**BUILDING
INNOVATIONS
AUSTRALIA**

ADAPTABLE HOUSING & LHDG INDICATIVE COMPLIANCE REPORT FOR DA LODGEMENT

**Lot 2, 1 Veno Street,
Heathcote NSW 2233**

Prepared for:	DK Heathcote Pty Ltd
Project No.:	PRO-08992-D6N4
Date:	04/07/2024
Status:	Report Issue v1.0

Figure 4 Level 1-3 Floor Adaptable Units Location on Architectural Plans

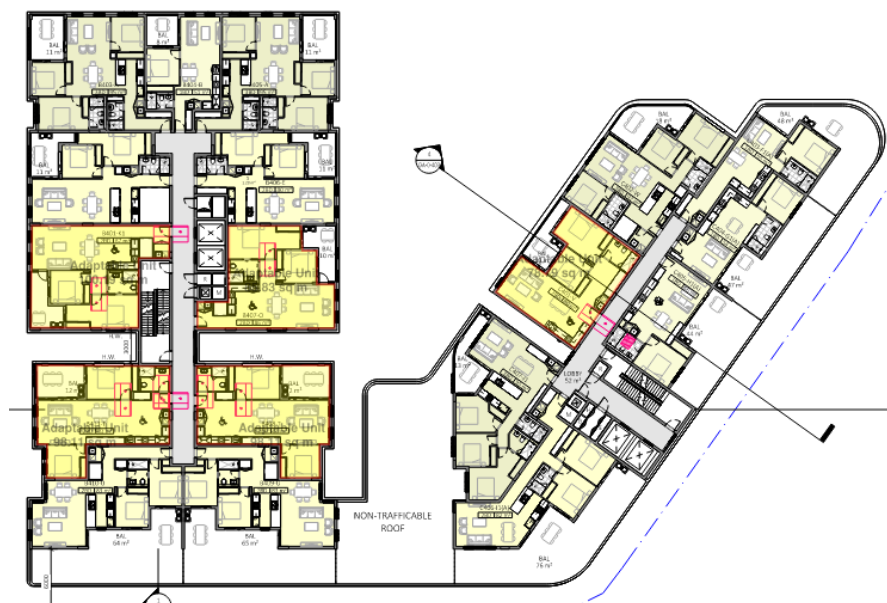
The following units have been designated as adaptable units, forming the basis of the review that follows:

- Units B101-N, B201-N & B301-N;
- Units B107-O, B207-O & B307-O;
- Units B411-T & B511-T;
- Units C101-V, C201-V & C301-V ;
- Units C105-Z(A), C205-Z(A) & C305-Z(A);
- Units C106-A1(A),C206-A1(A), C306-A1(A)
- Unit B401-N & B501-N;
- Units C401-V & C501-V;
- Units C408-T & C508-T;
- Units C401-V & C501-V.

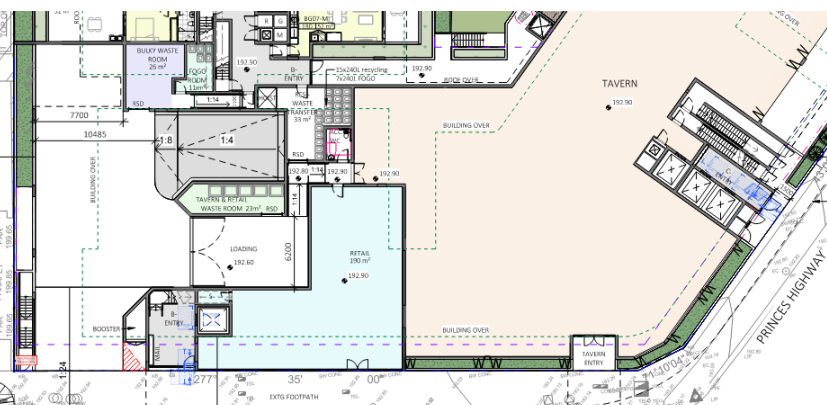
Item	Status	Item Description	References
1	CRA	<p>Provisions of the drawings showing the housing unit in its pre-adaptation and post-adaptation stages.</p> <p><i>To obtain certification as an adaptable housing unit, 'as built' drawings showing the housing unit in its pre-adaptation and post-adaptation stages shall be provided. A description of how the adaptation is to be achieved shall also be provided.</i></p> <p>Pre-adaptation stage layout has been provided for the designated units in architectural plans as illustrated below:</p> 	<p>Clause 2.3 - Potential for Adaptation</p>

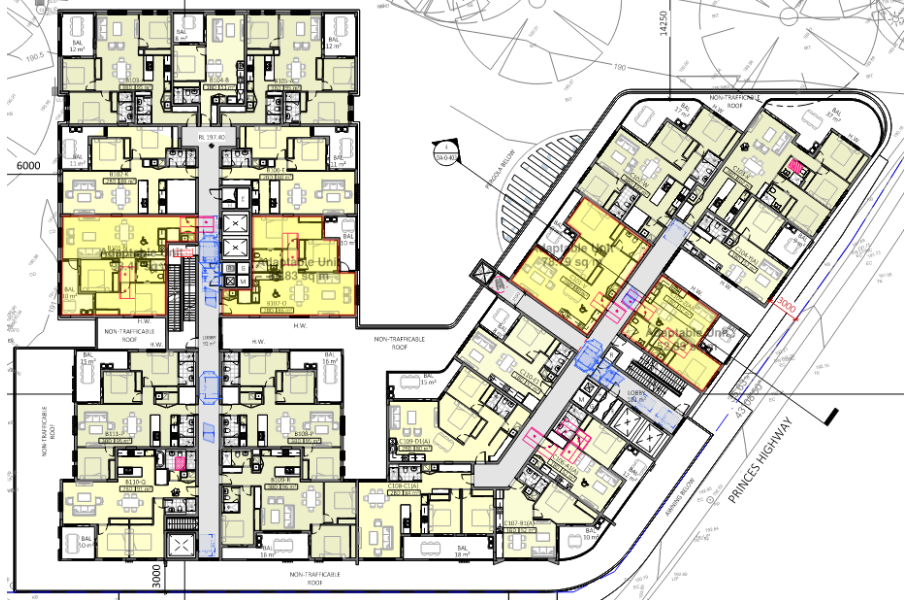
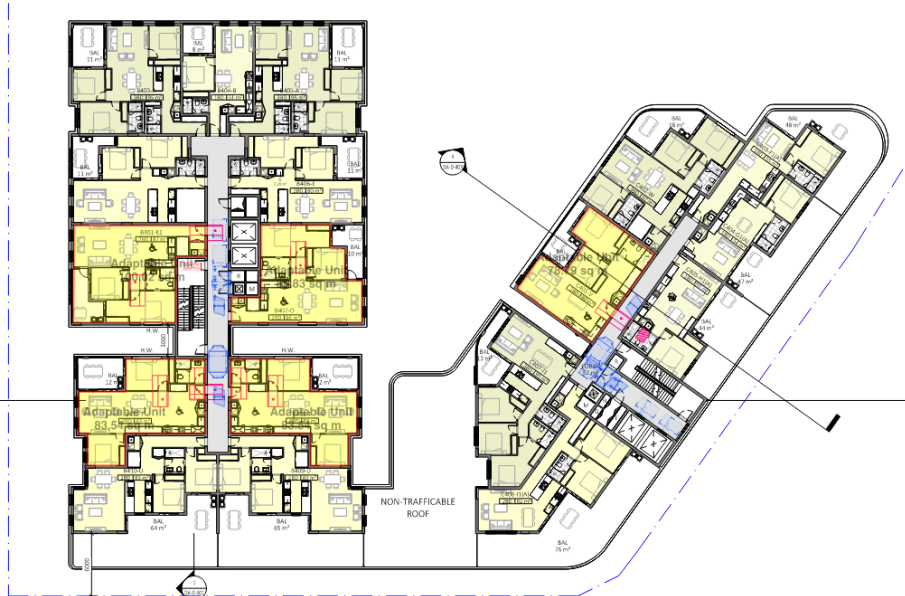
Drawings			
Item	Status	Item Description	References
		<p>Post-adaptation stage layout has been provided for the designated units in architectural plans as illustrated below:</p>  <p>Both pre and post adaptation plans have been provided to satisfy this item.</p>

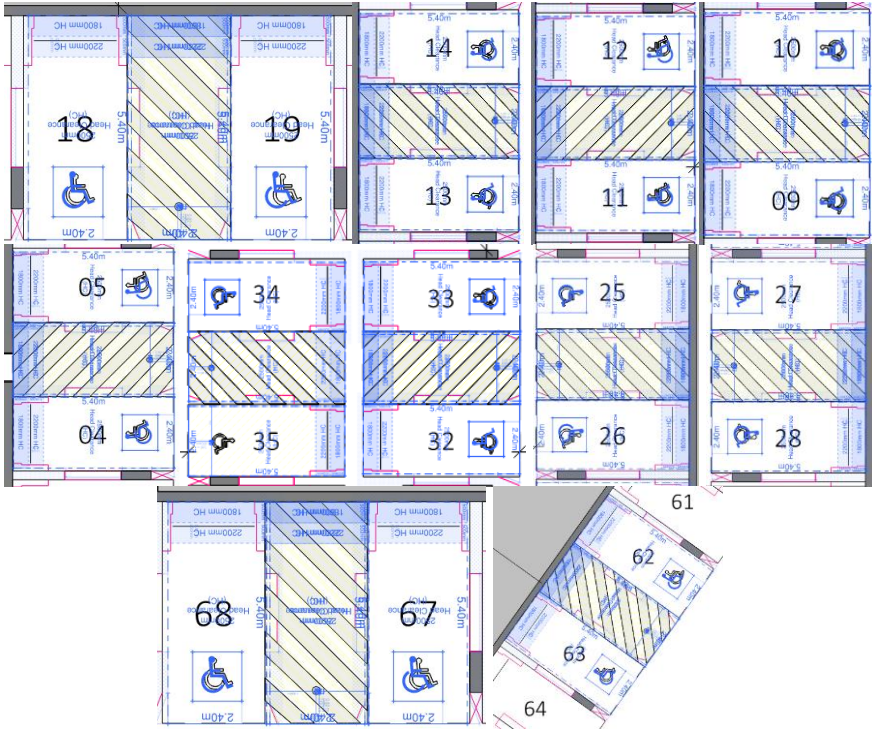
Siting			
Item	Status	Item Description	References
		 <p>First to Third Floor Accessible Path of Travel</p>  <p>Fourth to Fifth Floor Accessible Path of Travel</p> <p>Recommendation: Compliance can be achieved via slight redesign prior to the issue of the Construction Certificate.</p>

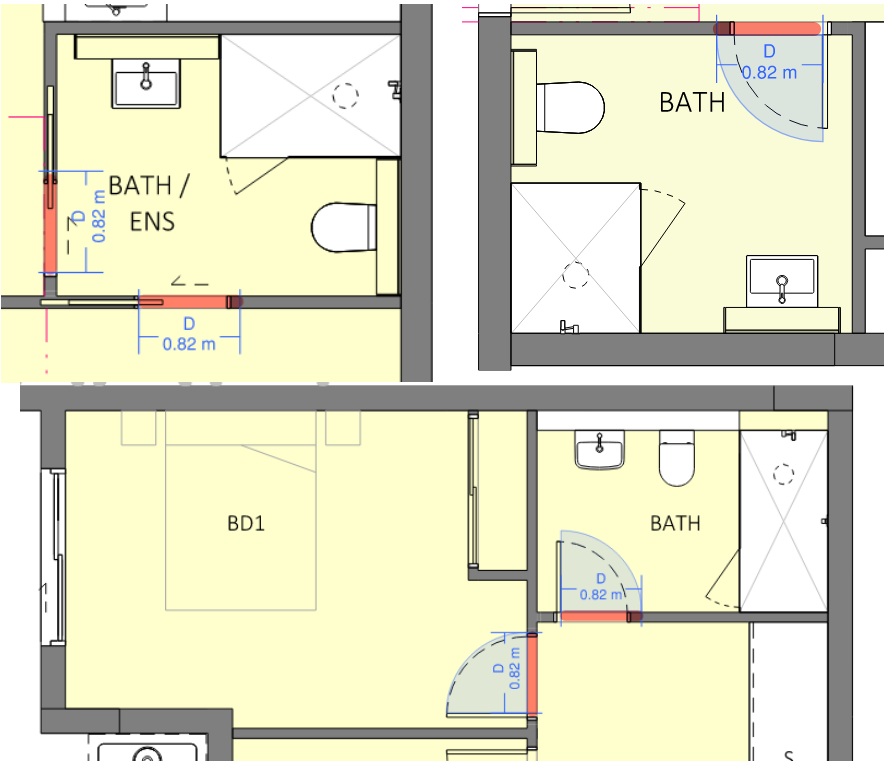
Item	Status	Item Description	References
		<p>As the requirement for the subject accessible entries to comply with AS 1428.2 is set by AS4299 and not by the Building Code of Australia (BCA) 2016, compliance with the requirements of the 1993 edition can be considered as sufficient.</p> <p>Below is a direct comparison of frontal-approach, swing-towards door circulation of 2001-edition dimension and 2009-edition dimensions, illustrating AS1428.1-2009 provides the same length as AS1428.2 based on 2001-edition, with greater latch-side circulation space, which is more important for independent access than hinge-side circulation space:</p> <p>Although compliance with AS1428.1-1992 & AS1428.1-1993 is the minimum requirement for compliance with AS4299-1995, based on the above, this office considers compliance with AS1428.1-2009 required, and AS1428.2-1992 dimensions added to AS1428.1-2009 as highly desirable.</p> <p>The subject SOU entry doorways appear to comply with AS1428.1-2009 (blue) and AS1428.2-1992 (orange) at post adaptation, with the exception of Unit Type V & Type (Z) as illustrated below:</p> <p>Action: Compliance can be achieved via slight redesign prior to the issue of the Construction Certificate.</p>

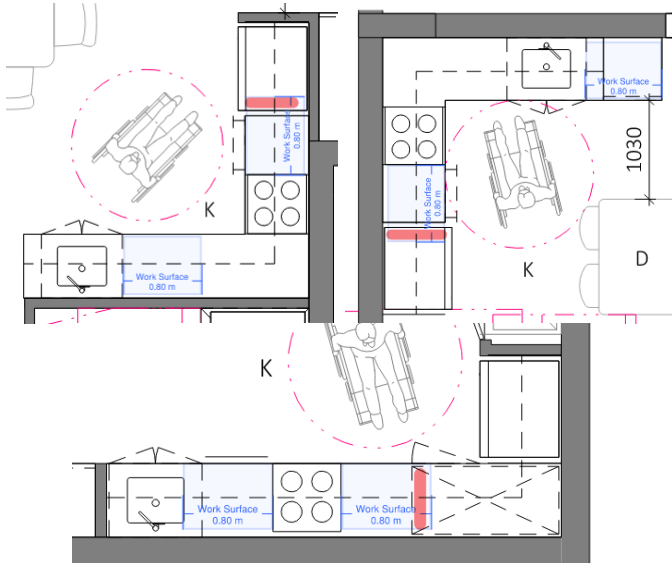
Item	Status	Item Description	References
		<p>AS 1428.1-2009 58</p> <p>59</p> <p>AS 1428.1-2009</p> <p>LEGEND: D = Clear opening of width of doorway L = Length WH = Width—hinge side WL = Width—latch side → = Direction of approach ↔ = Circulation space</p> <p>DIMENSIONS IN MILLIMETRES</p> <p>FIGURE 31 (in part) CIRCULATION SPACES AT DOORWAYS WITH SWINGING DOORS</p> <p>Internal corridors shall have a minimum width of 1000 mm. After adaptation, circulation spaces at doorways shall comply with AS 1428.1.</p> <p>Provision for doorway approach circulation spaces for the main toilet and common facilities to comply with AS 1428.1-2009 with minimum 820mm clear door width as allowed by Item 32 for the subject units appear to be provided at post-adaptation, with the exception of Unit Type V, as illustrated below:</p> <p>Recommendation: Compliance can be achieved via slight redesign prior to the issue of the Construction Certificate.</p>

Figure 9 *Fourth to Fifth Floor Livable Unit Location(s) on Architectural Plans*

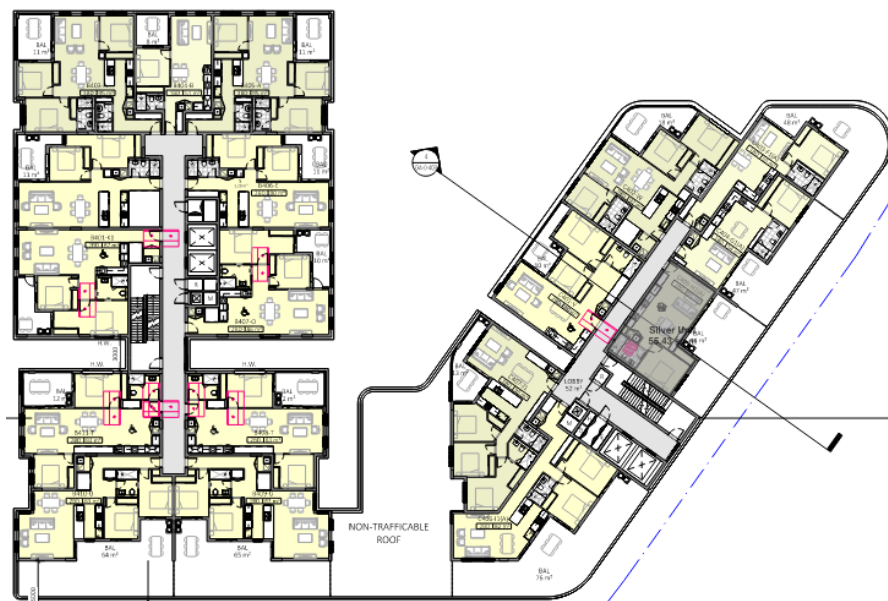
The following units within the development have been designated as Silver level Livable units, forming the basis of the review that follows:

- Unit B110-Q;
- Unit B211-H & B311-H ;
- Unit C203-X & C303-X;
- Unit C103-X;
- Unit B209-H & B309-H ;
- Unit C-405-H1A & C-505-H1A;
- Units C106; C206 & C306 (to be relabelled as LHDG silver level)

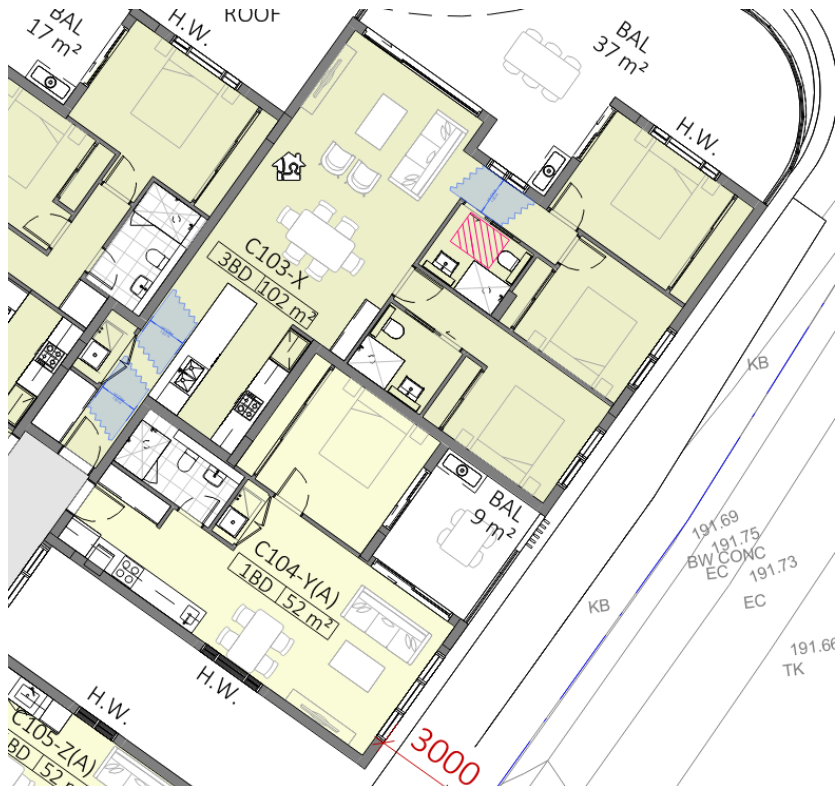
SOU entry doorways with not less than 820mm clearance, with a level 1200mm x 1200mm space at the landing of the subject unit entry appears to be provided:

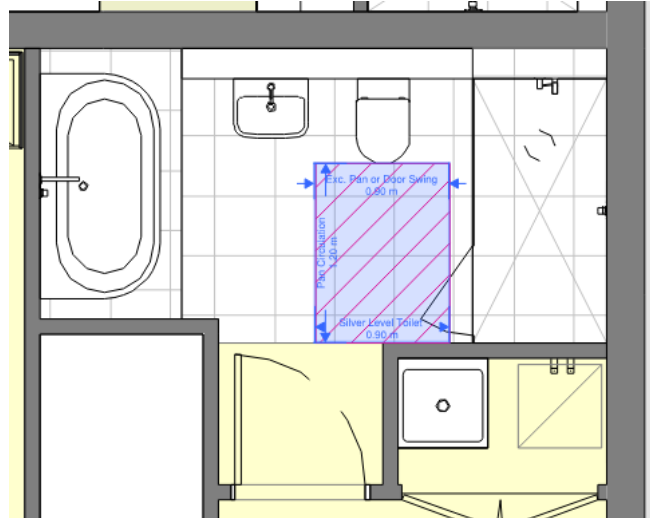
Status	Item Description
CRA	<p>Performance Statement: Internal doors and corridors facilitate comfortable and unimpeded movement between spaces.</p> <p>a. Doorways to rooms on the entry level used for living, dining, bedroom, bathroom, kitchen, laundry and sanitary compartment purposes should provide:</p> <ol style="list-style-type: none"> a minimum clear opening width of 820mm (see Figure 2(a)); and a level transition and threshold (maximum vertical tolerance of 5mm between abutting surfaces is allowable provided the lip is rounded or beveled). <p>b. Internal corridors/passageways to the doorways referred to in (a) should provide a minimum clear width of 1000mm.</p> <p><i>* Corridor widths should be measured as described in Clause 6.3 of AS 1428.1 – 2009</i></p> <p>Minimum internal corridors of 1000mm dimensioned throughout subject units appear to be provided.</p> <p>Minimum internal doorway clearance of 820mm provided to doorways leading to living, dining, main bedroom, kitchen and laundry within subject units</p>  <p>Recommendation: Ensure minimum 1000mm width clearance is provided to all units door prior to issue of the Construction Certificate.</p>

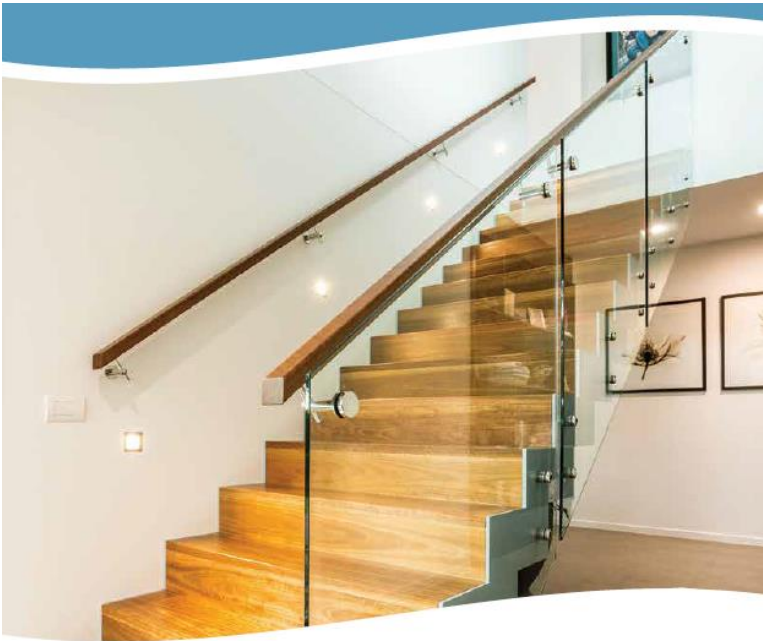
The subject units appear to have provisions for the reinforcement of bathroom & toilet walls in at least one sanitary compartment, as required by this section.

Note to be added to plans prior to the issue of the Construction Certificate.
